Application for a Certificate of Public Convenience and Necessity (CPCN) for the Tilbury Liquefied Natural Gas (LNG) Storage Expansion (TLSE) Project (Application)

Response to the Commercial Energy Consumers Association of British Columbia (CEC) CONFIDENTIAL Information Request (IR) No. 2 – Filed Non-Confidentially

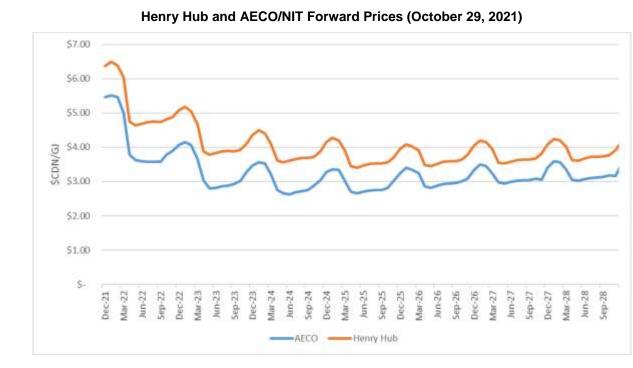
- longer duration resiliency requirements are best achieved with pipeline capacity. Please also refer to the response to BCUC IR1 16.3.
- 122.1. The CEC understands that natural gas prices may be expected to rise over time. Does FEI derive a cost benefit or risk from having on-system storage? Please explain.
- 7 8

10 FEI is not certain that natural gas prices will only rise over time, as prices fluctuate based on

11 evolving market supply and demand fundamentals. For example, the natural gas prices for the

12 upcoming winter season have reached some of their highest levels in years; however, the forward

13 prices project a price drop back down to between \$3.00 and \$4.00 CAD/GJ over time (as shown

14 in the figure below).
